Source: Prestolite Leece-Neville Heavy Duty Systems
Bulletin No: TSB-1223 **Date:** February 3, 2023
Models: A0014833LCH, A0014833LGH (4833LGH) A0014842LCH
Subject: Terminal identification to AVI160J2014

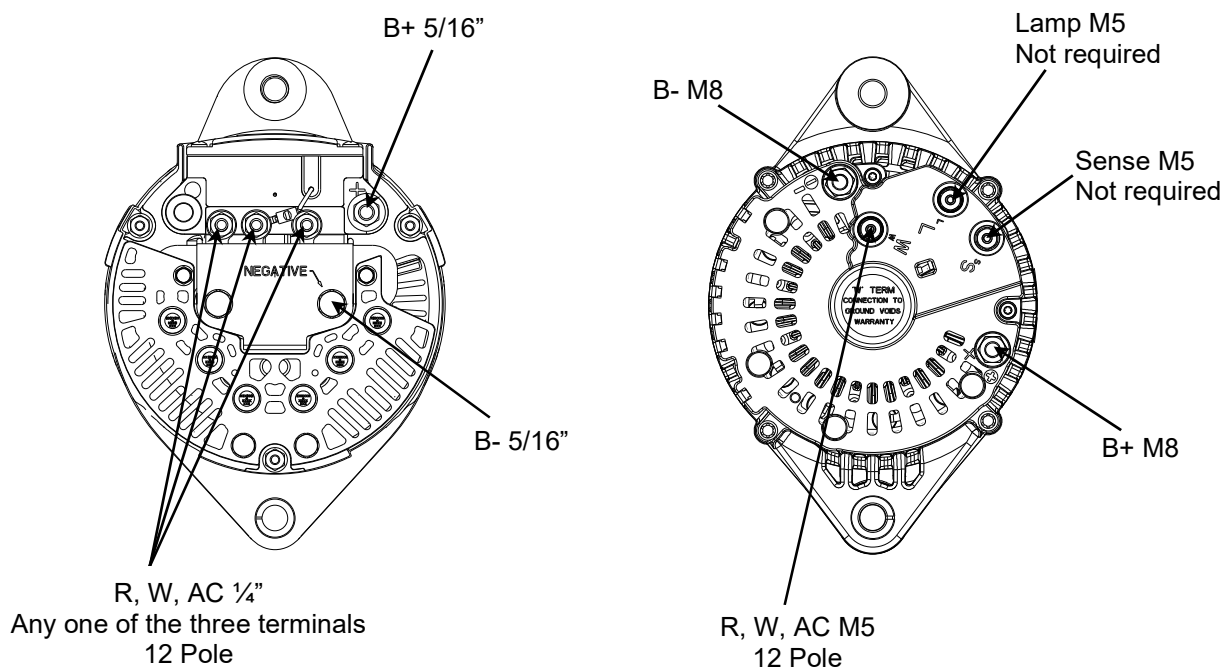
This document will help identify terminal location variances.

Alternators listed in this TSB are discontinued and replaced by a newer AVI160 family of alternators.

Both original and replacement AVI160 are self-excited alternators.

For basic operation the AVI160 only requires connections to the B+ and B- terminals.

The original alternators are grounded earth return. The AVI160 series replacements are insulated return.

Depending on the vehicle wiring a ground strap maybe required between the B- terminal and chassis ground.

Note: AVI160 have internal cooling fans. External fan used on the original alternators are not needed.
